SUBJECT: FORWARDS RESPONSES TO ROUND ONE, SET THREE QUESTIONS FROM  
 AUXILIARY SYS BRANCH. RESPONSES WILL BE INCORPORATED IN FSAR.

Subject: WPPSS NUCLEAR PROJECT NO. 2  
RESPONSES TO ROUND ONE  
QUESTIONS, SET THREE - ASB

Auxiliary Systems Branch Questions  
(10.10 - 10.34)

FIG. 9.27a

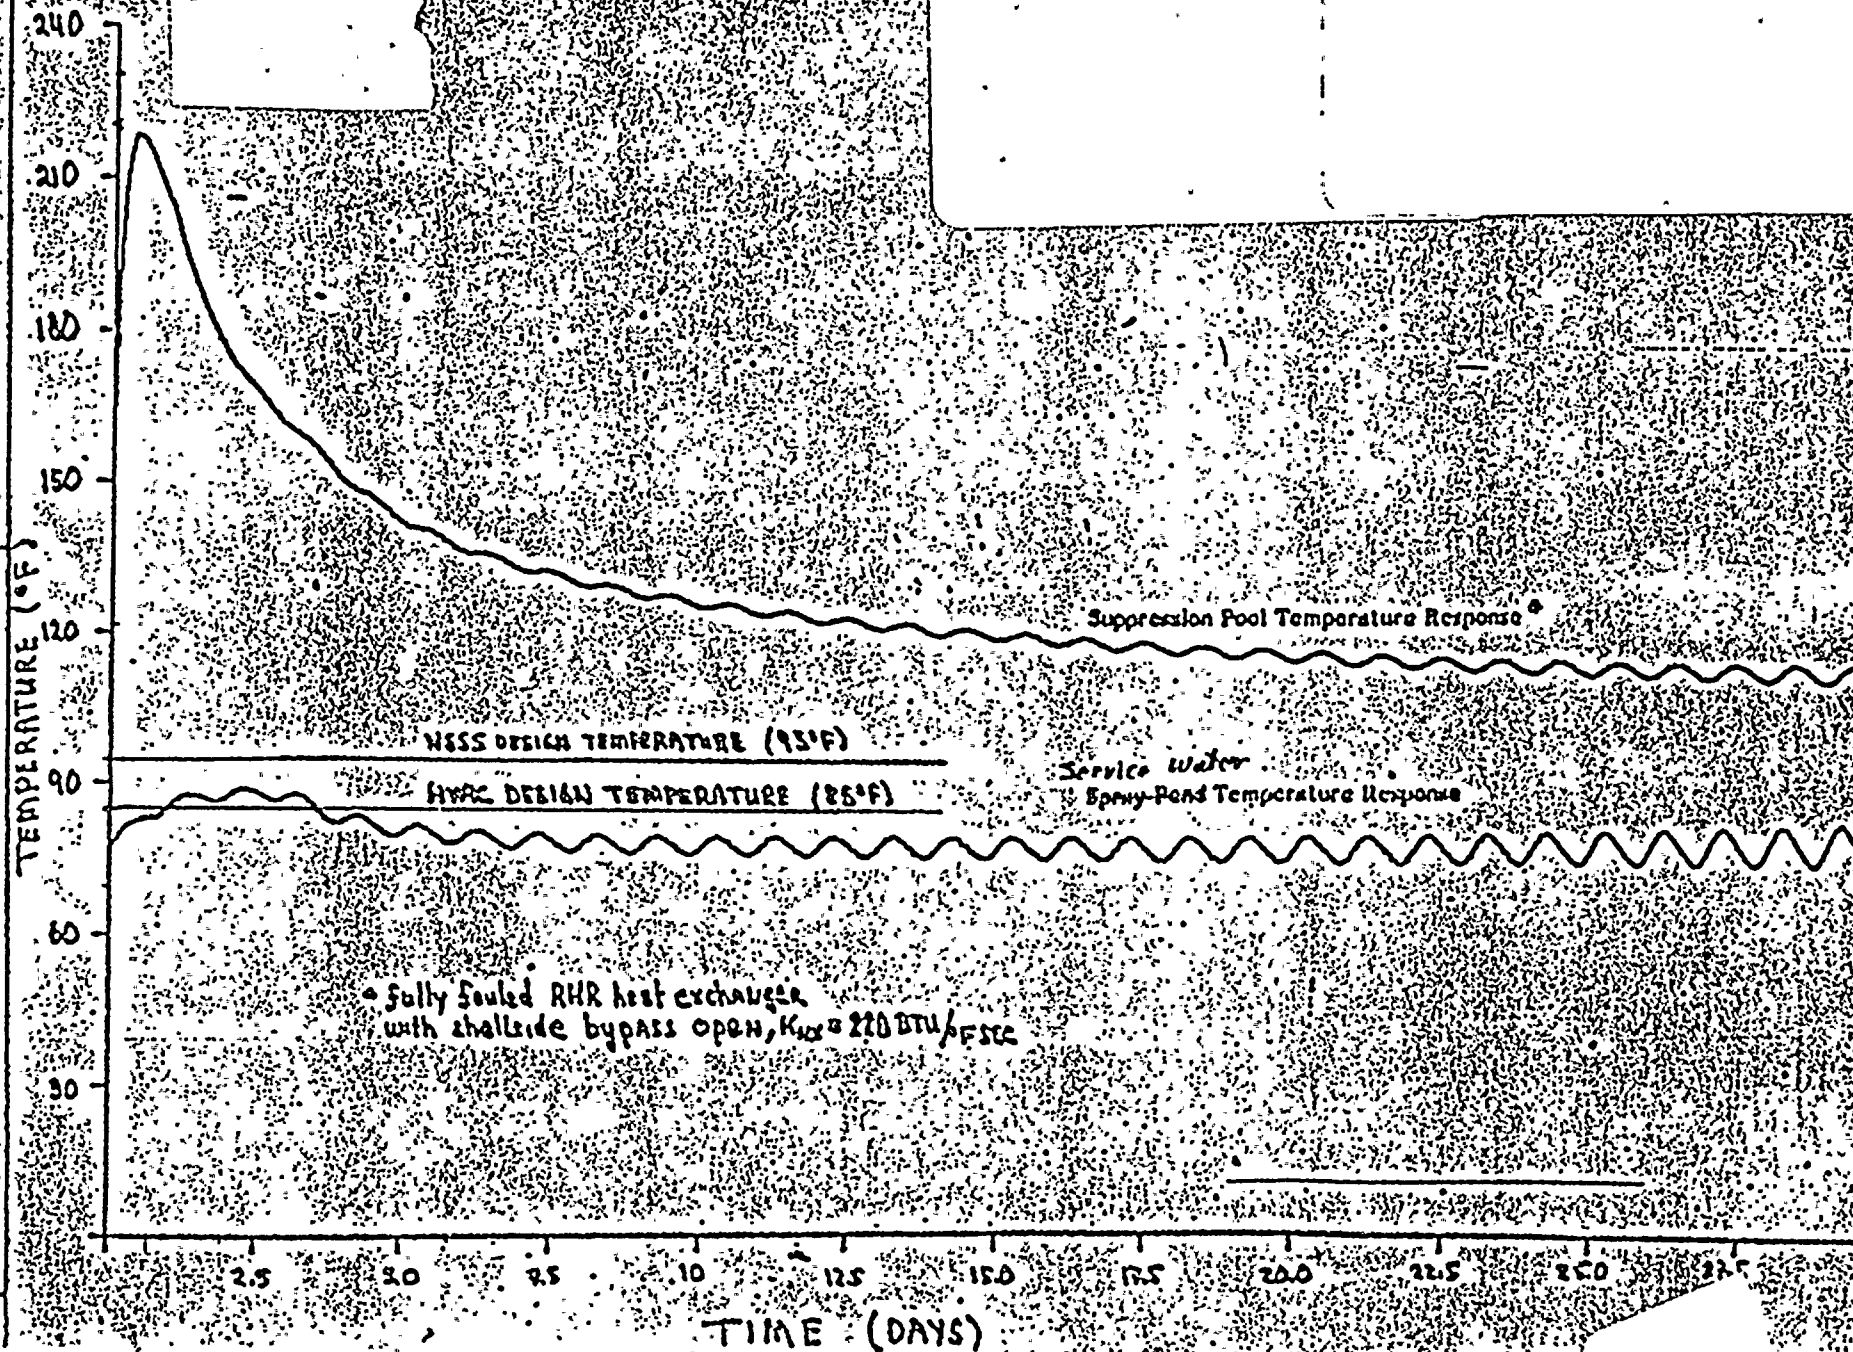
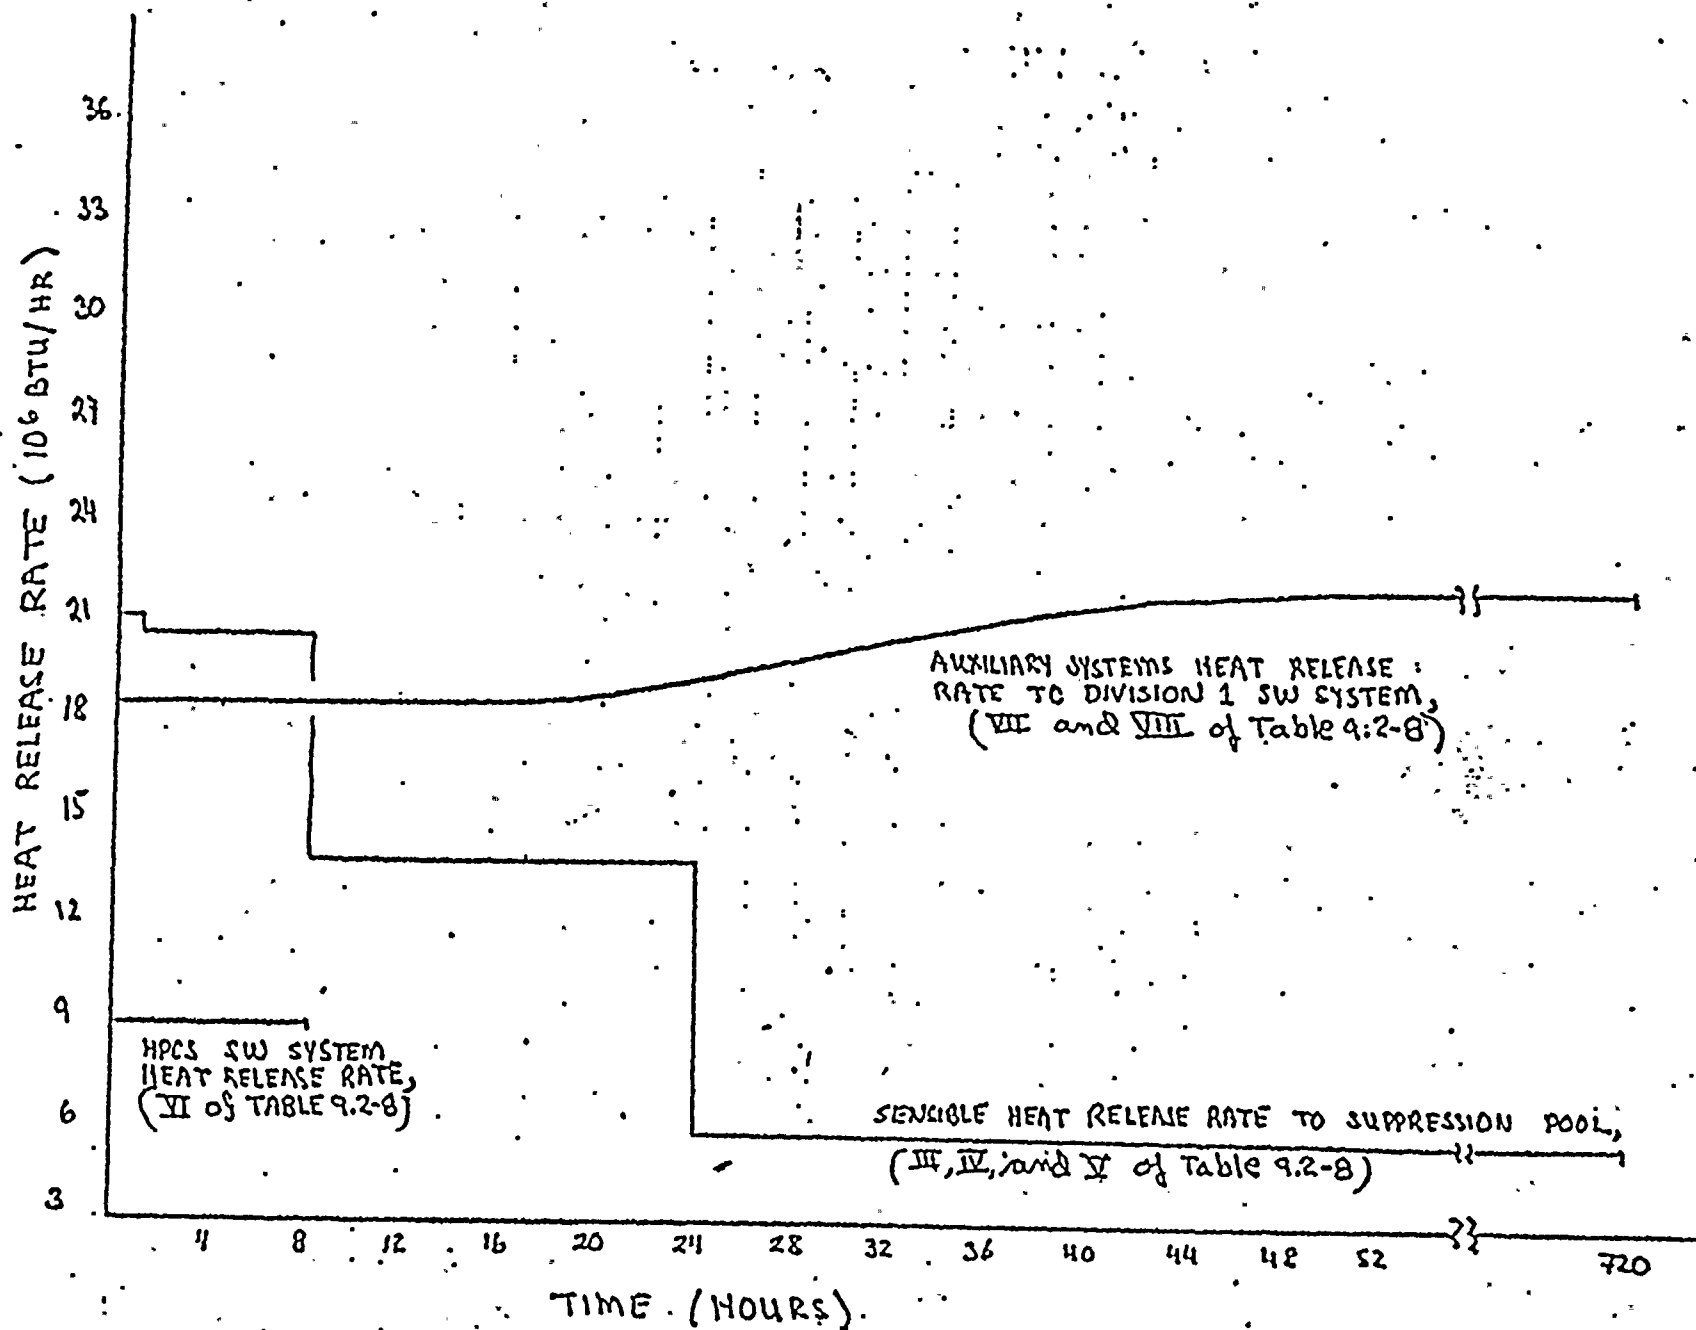
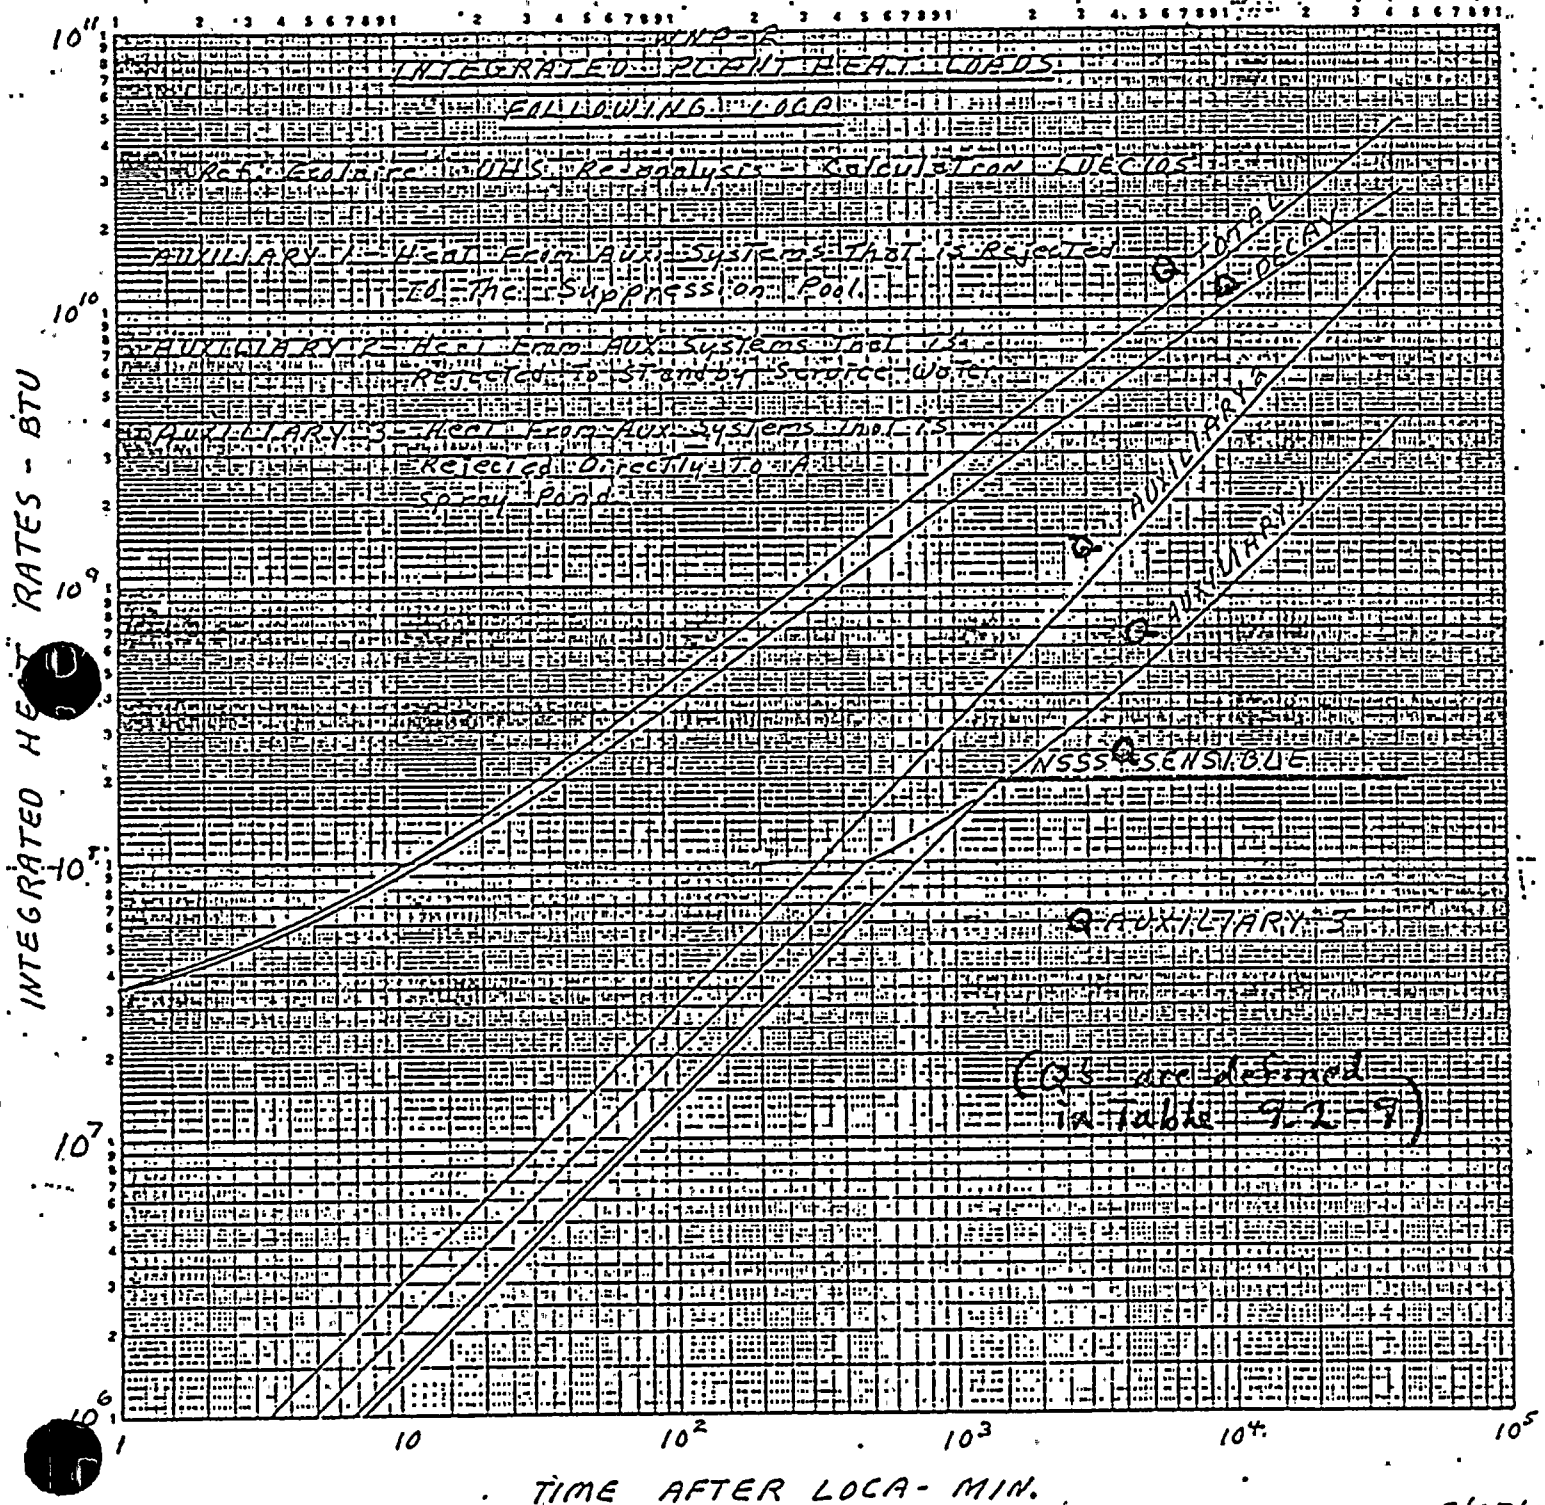
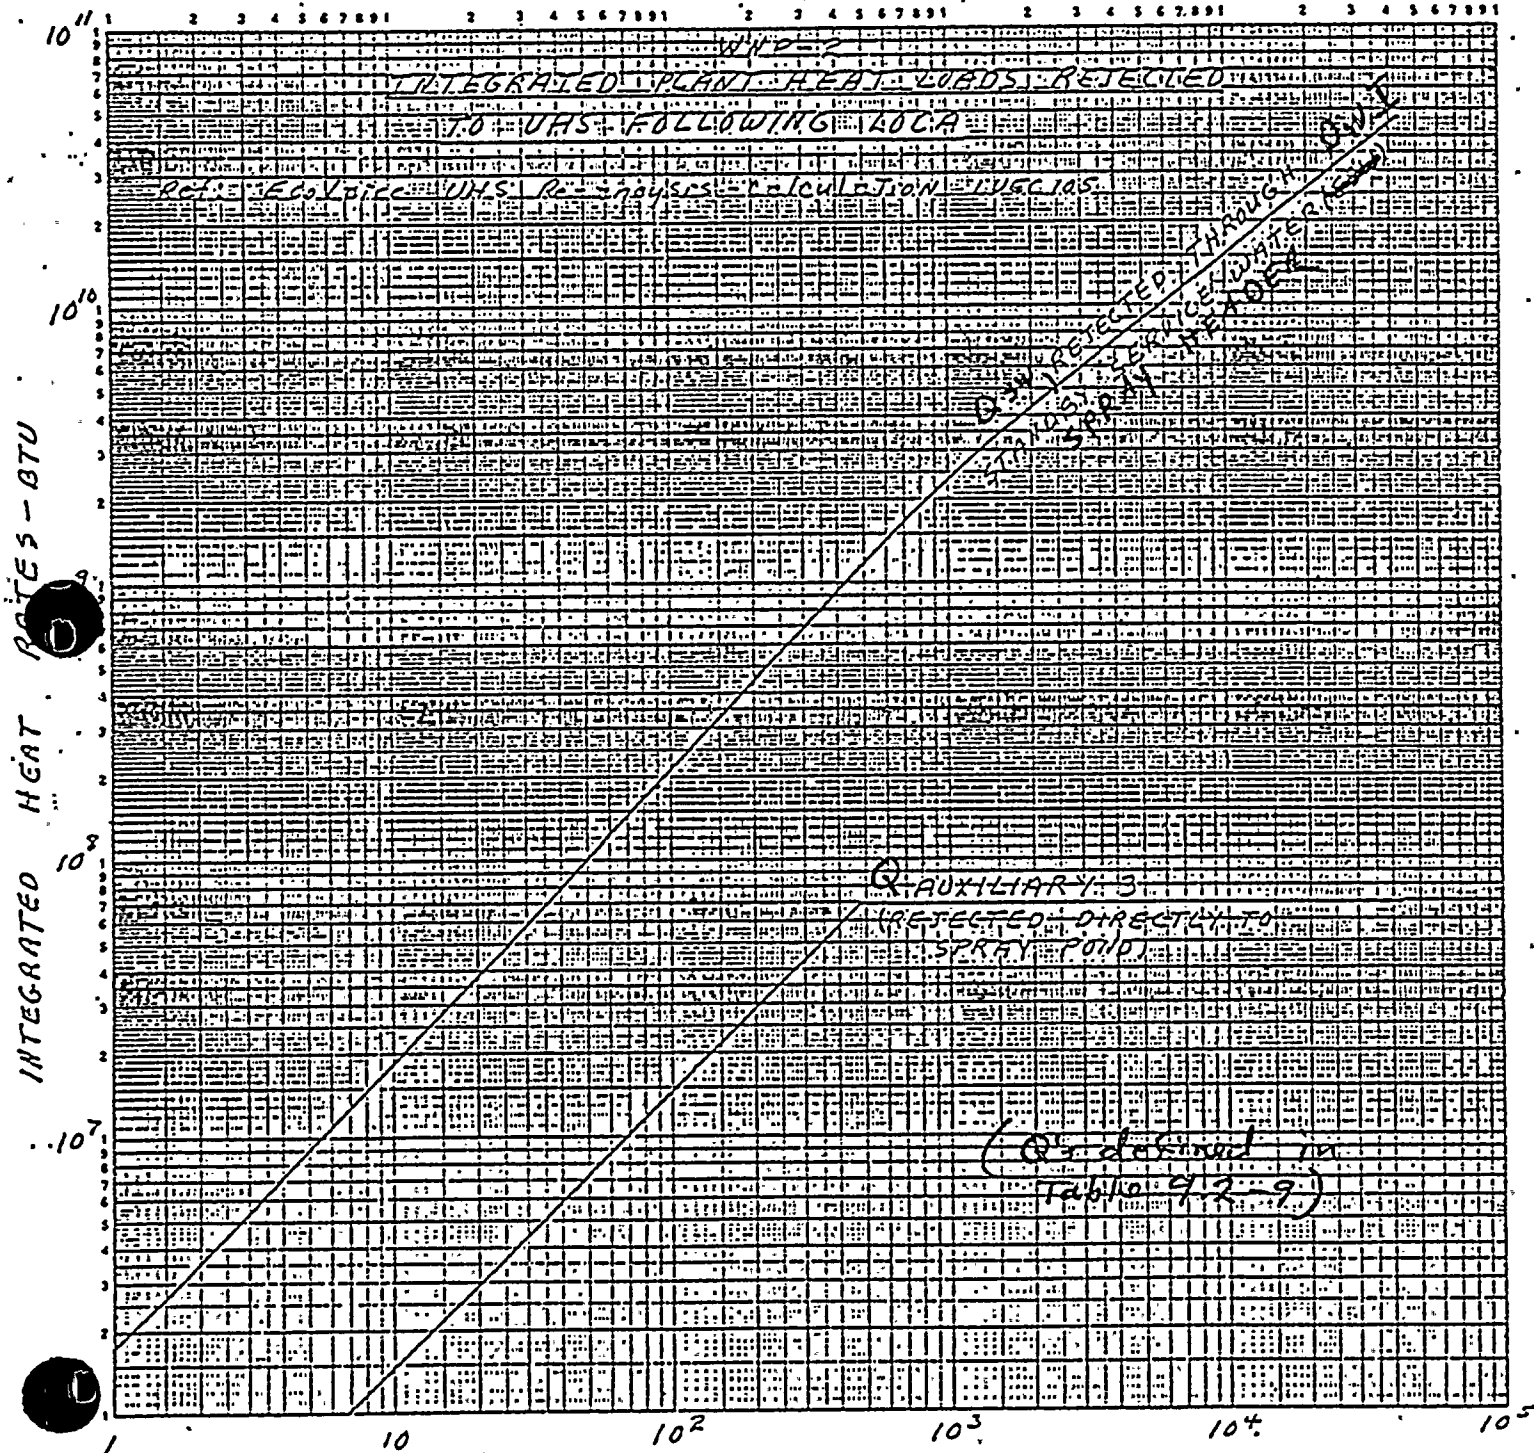
Provide the results of your analysis of the capability of the ultimate heat sink to absorb heat over a thirty-day period following a postulated design basis accident. Indicate the total heat absorbed in the ultimate heat sink, including the sensible heat, the station auxiliary system heat, and the decay heat released by the reactor core. In particular, provide the following information in both tabular and graphical formats:

See revised Section 9.2.5\* which provides the revised results of the analysis including the information requested above. This revision also addresses the concerns of Question 371.6.

Using the assumptions stated earlier, two analyses were run. The first assumed a clean RHR heat exchanger and the second assumed a fouled heat exchanger. The pond temperature transient for the first analysis is shown in Figure 9.2-7. The pond temperature peaks at 87.0°F on the thirtieth hour. The mass inventory is shown in Figure 9.2-8, and the mass losses are tabulated in Table 9.2-3. The diurnal oscillations in pond temperature are due to the changes in solar loading. The second analysis yielded a peak pond temperature of 174°F lower and at the same hour after the accident. The only significant difference between the two analyses is
